KARACHI MUNICIPALITY.

ORDER UNDER SECTION 96 (2) OF ACT. III OF 1901.

I have to inform you that the plan submitted by you for building
addition & alteration on plot No. *69, 70* sheet No. *Ind-1, Market*
 Quarter, is approved and permission to build in accordance therewith is
 granted. The building must be erected in accordance with the approved
 plans and deviations should not be made without previous sanction of the
 Municipality.

With reference to your letter No:
L.M.A/B.S P.B 119/3 dated 4/4/30, we have
the honour to submit herewith fresh plans
showing additions & alterations on plot Nos:
69, 70 & 74 sheet M.R. 1 and shall thank you
to pass them at an early date.

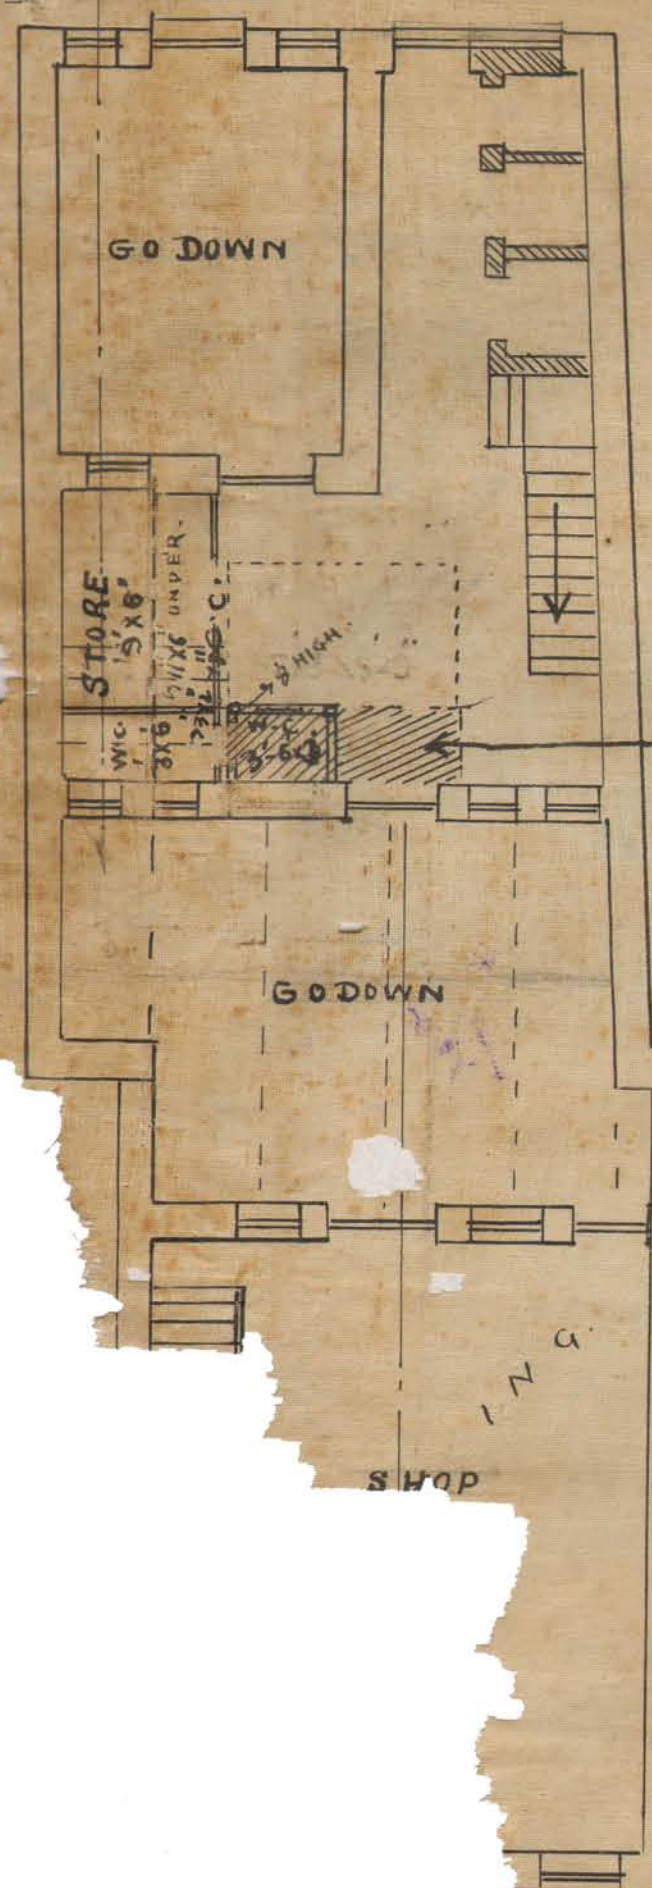
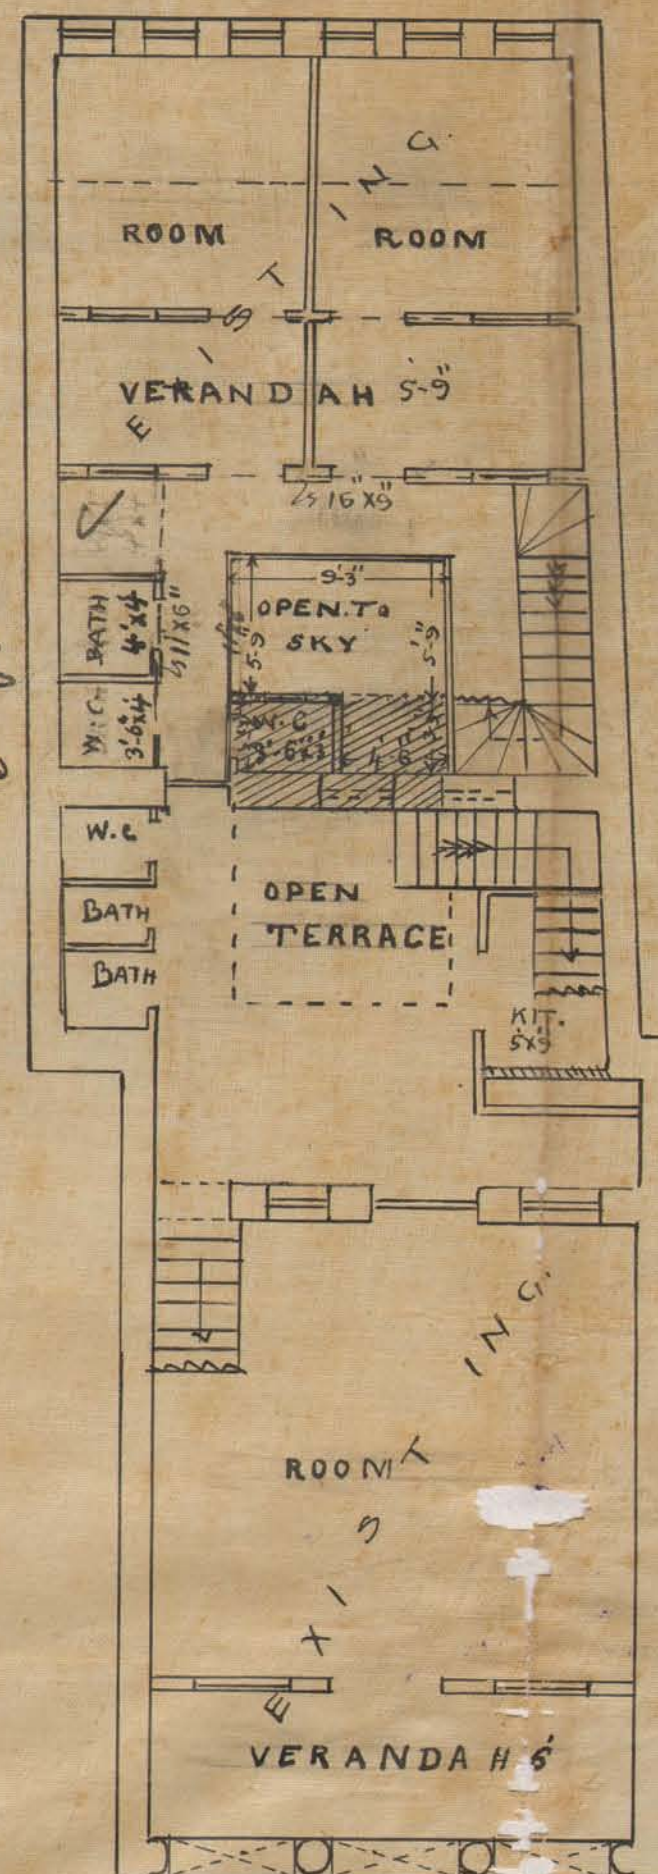
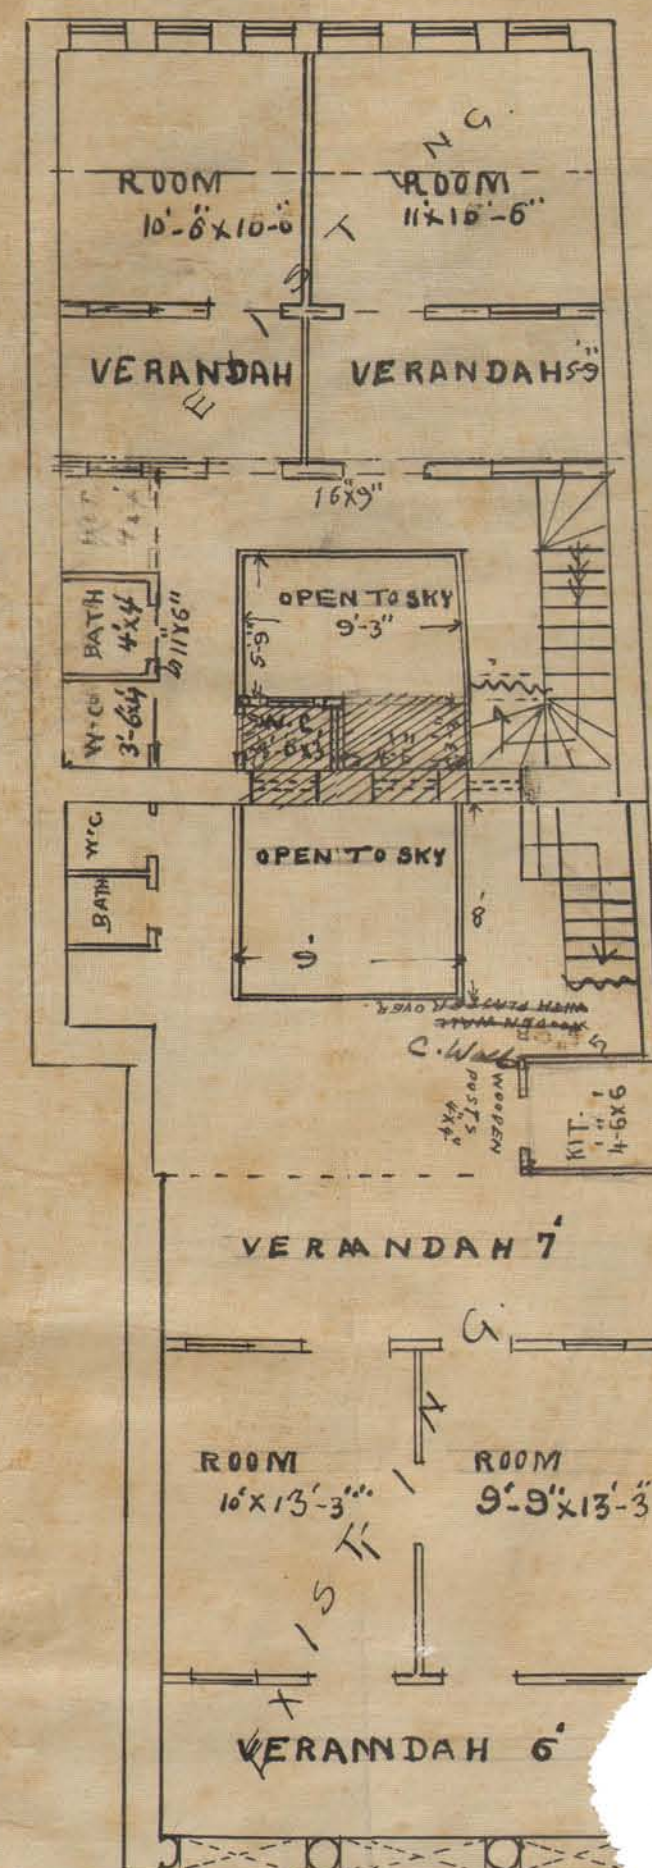
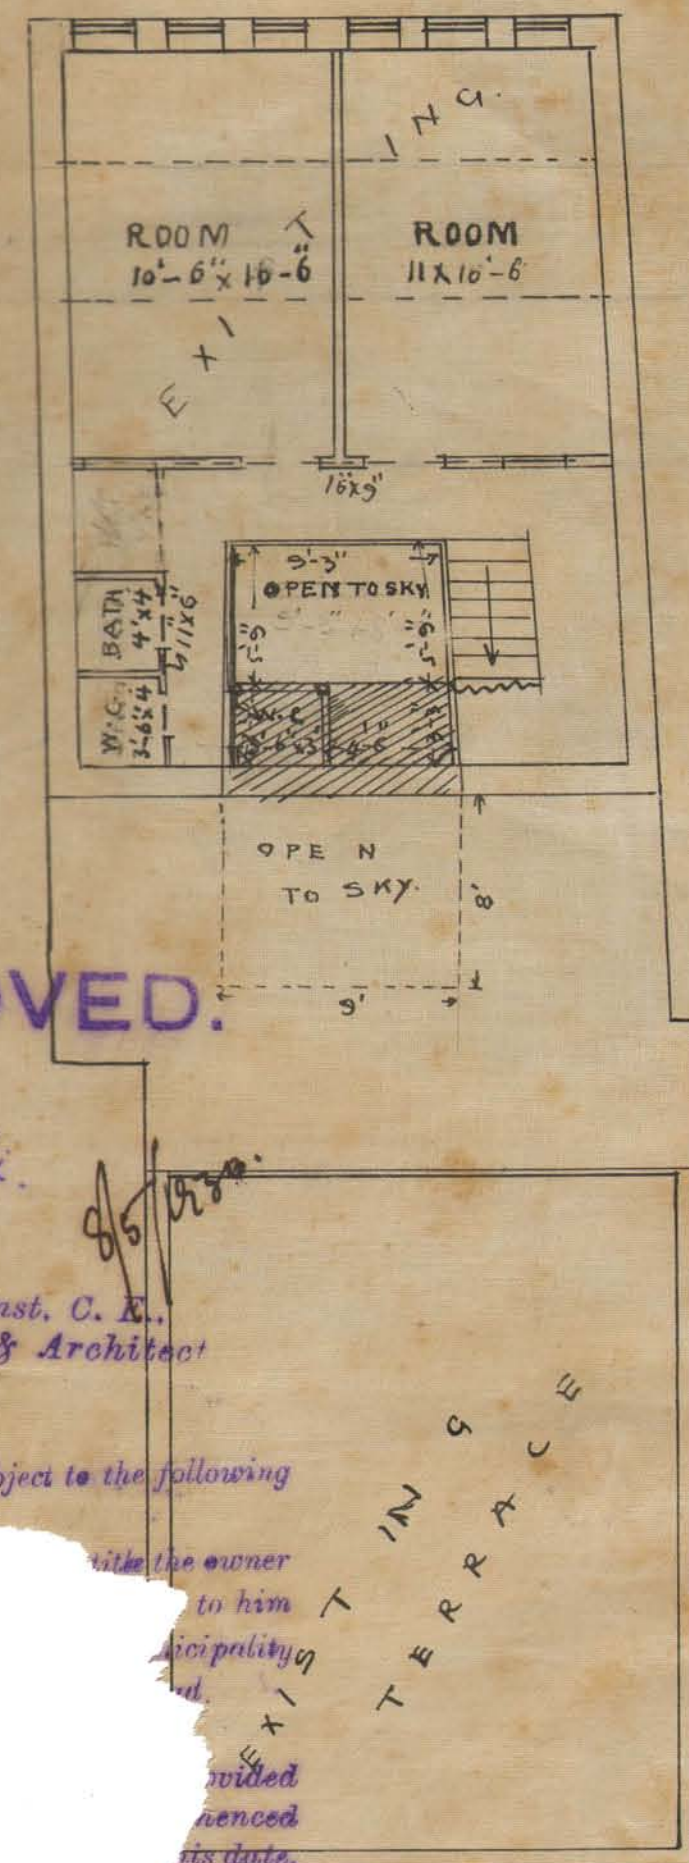
Submitted. The architect has
submitted fresh plans showing
w. c. etc.

APPROVED.

PLAN
SHOWING PROPOSED A.D. A.L.T.
ON 70874 SHEET M.R.I.
ARTER

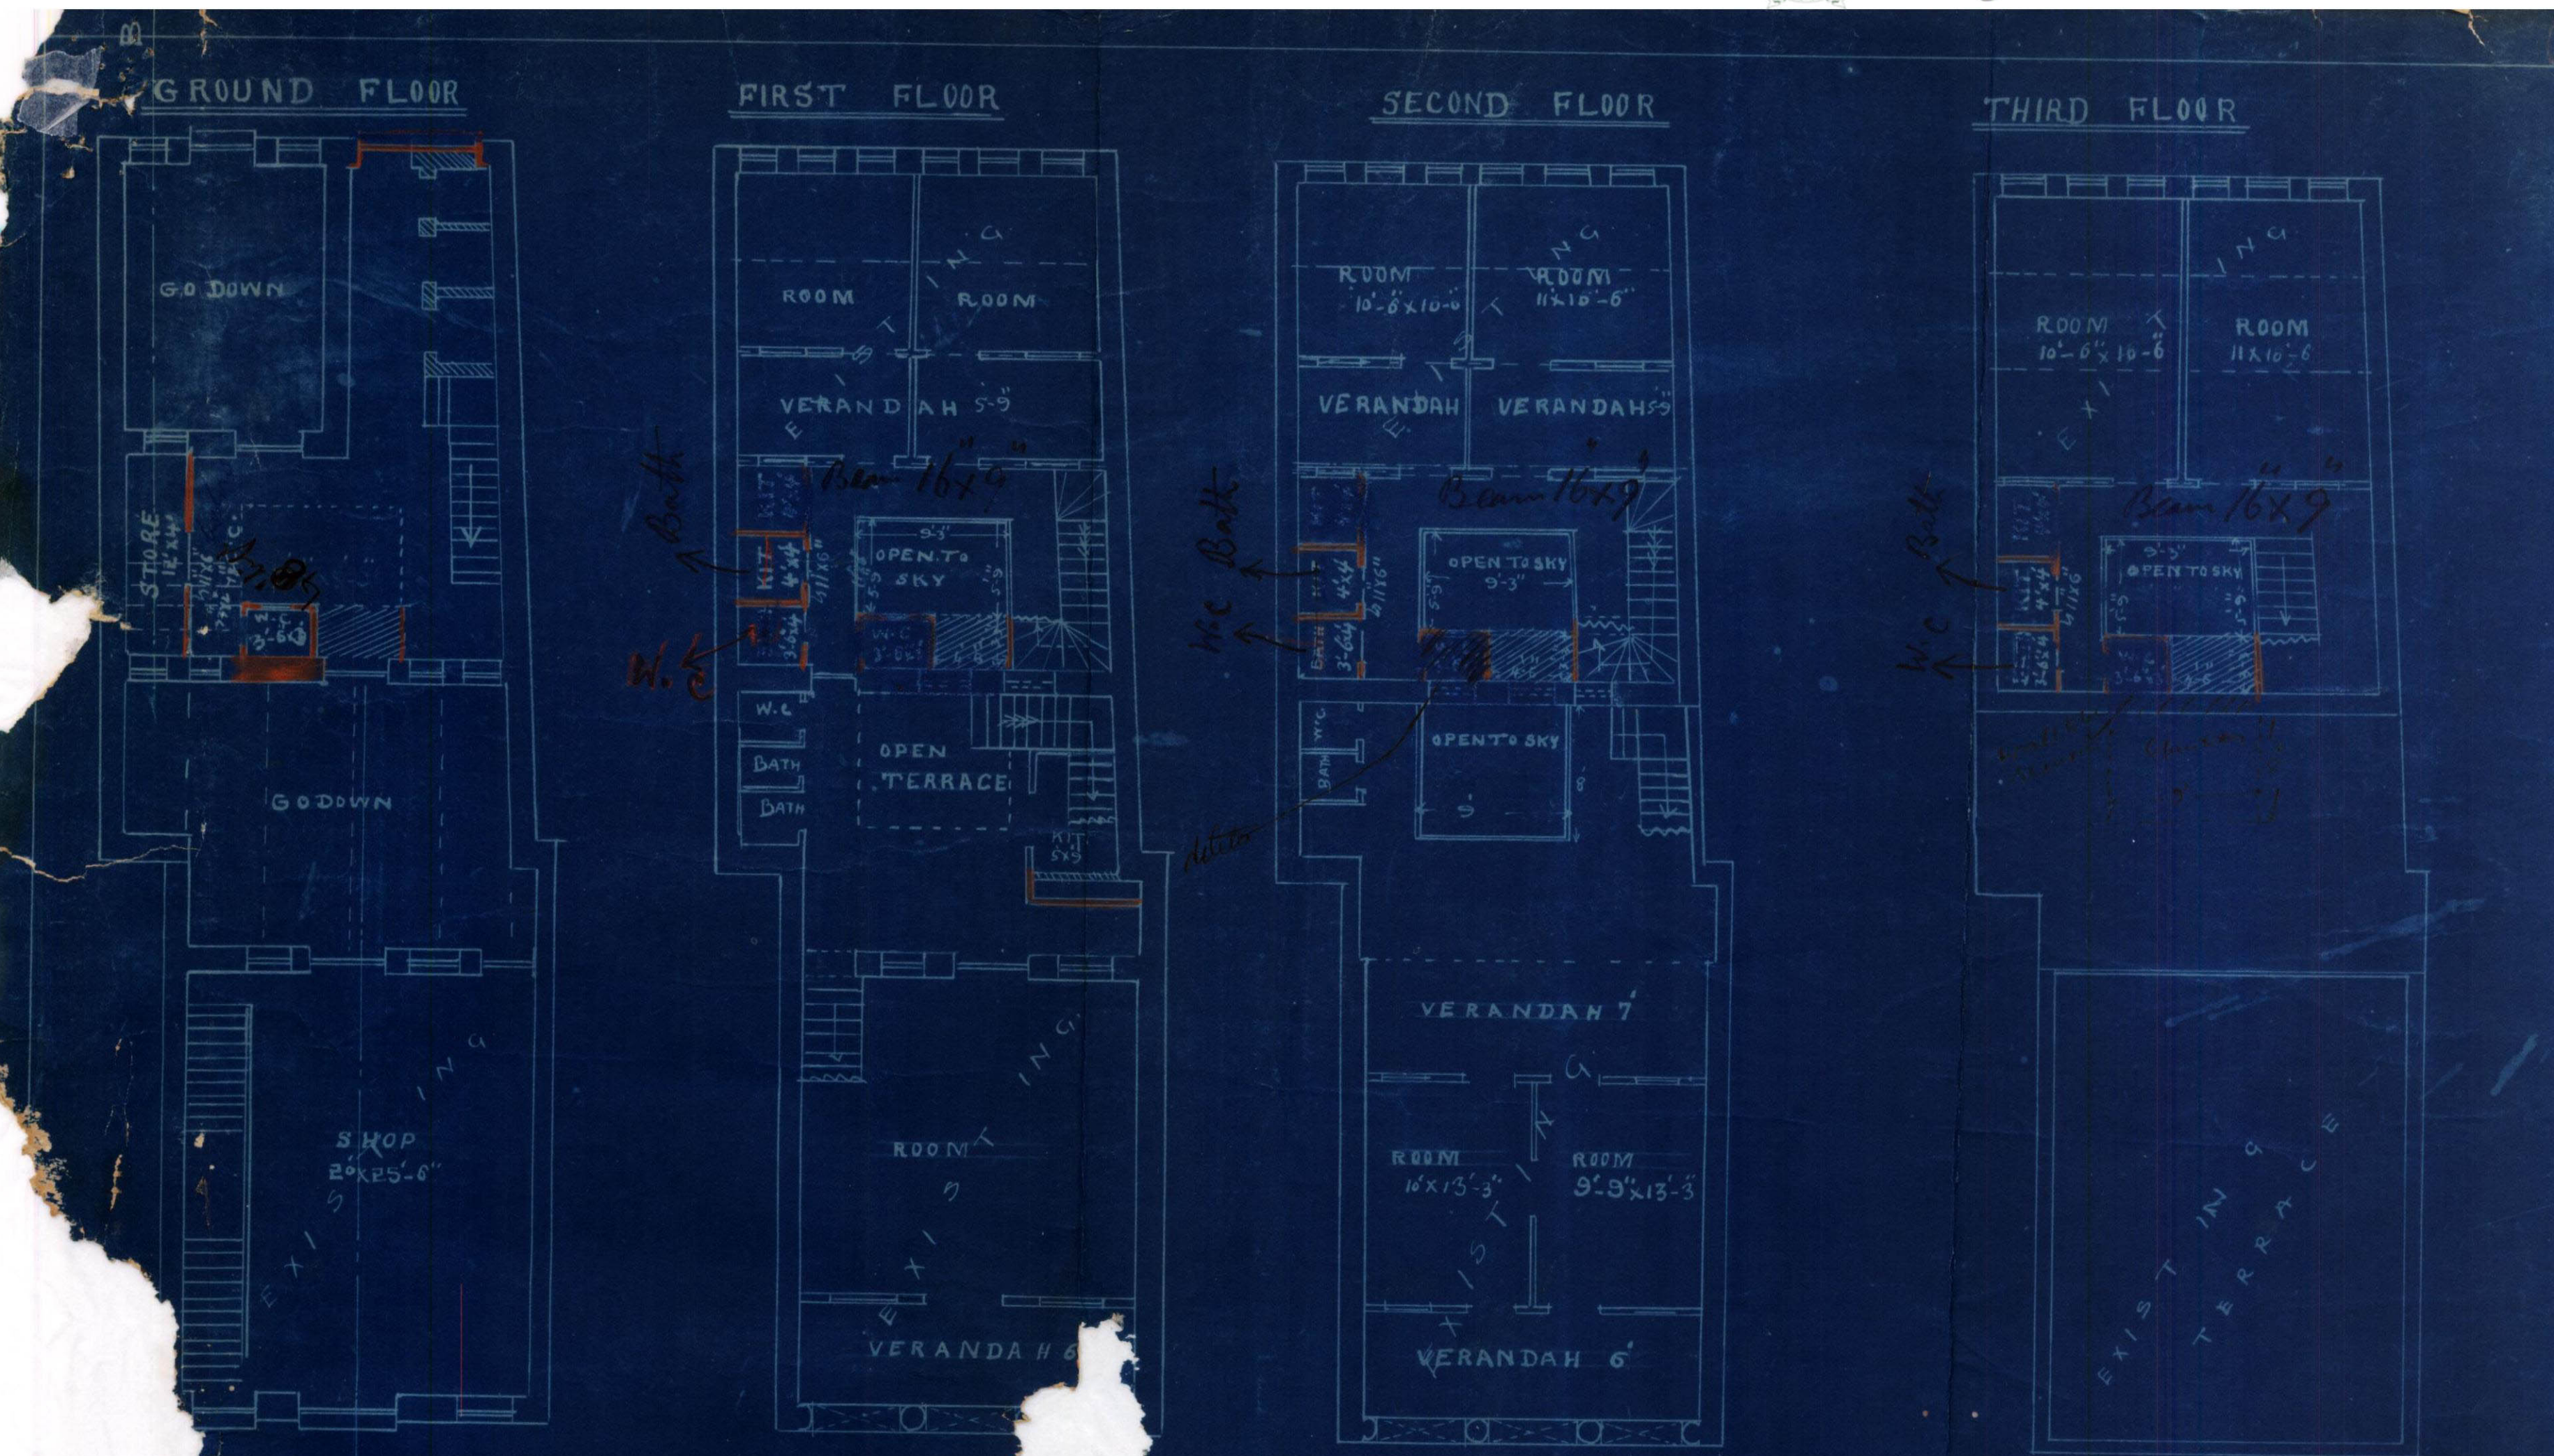
- (1) *Little shed must be removed.*
- (2) *The building is dark & hence open to sky must be increased kitchen platform and bath (now)*
- (3) *may be provided in the verandah.*
- (4) *Existing bath & kitchen with wooden walls must be removed.*
- (5) *In the arrangement proposed the partition walls must have beams below them.*
- (6) *Steps should not be allowed to encroach on Municipal land.*
- (7) *D.C. Cannot be allowed on the narrow open space which needs to be increased.*
- (8) *Size of existing posts, beams, etc., must be shown.*
- (9)

(1) Title deed must be produced.

(2) The building is dark and hence ~~black~~ black

sun to stay must be increased and kitchen

(bath) and bath may be provided in the veranda

(3) Existing bath and kitchen must be removed

(4) In the arrangement proposed, the parties must have beams below them.

B.S's objection, Shop should not be allowed
to encroach on municipal land, W.C cannot be
allowed on the narrow open space which has
to be reserved. Size of building to be made
smaller.
